VEHICLE SAFETY DEFECT SERVICE BULLETIN

Recall Campaign 05V223000 US Units

Re: Safety Recall- Aqua-hot/Hydro-hot Burner Tube:

AQUA-HOT/HYDRO-HOT BURNER TUBE REPLACEMENT

Figure 3

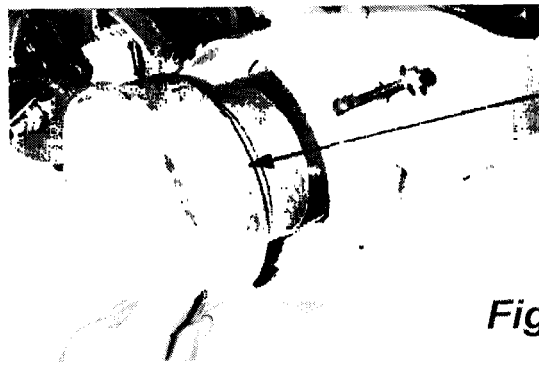
NOTE: The wiring harness and fuel lines are positioned to allow burner head vertical placement with clearance to remove the combustion chamber. (Figure 3)

Figure 6

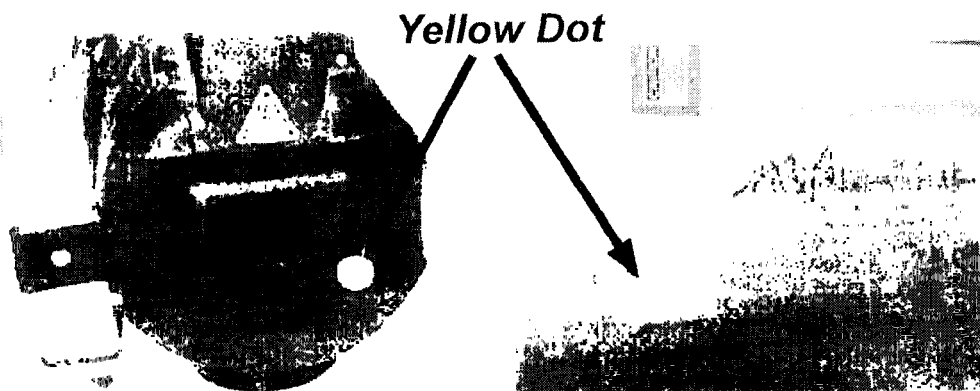
10. Place the yellow dot stickers on the front side of the burner head and on the outside data plate to identify that the recall is complete. (Figures 6 & 7)
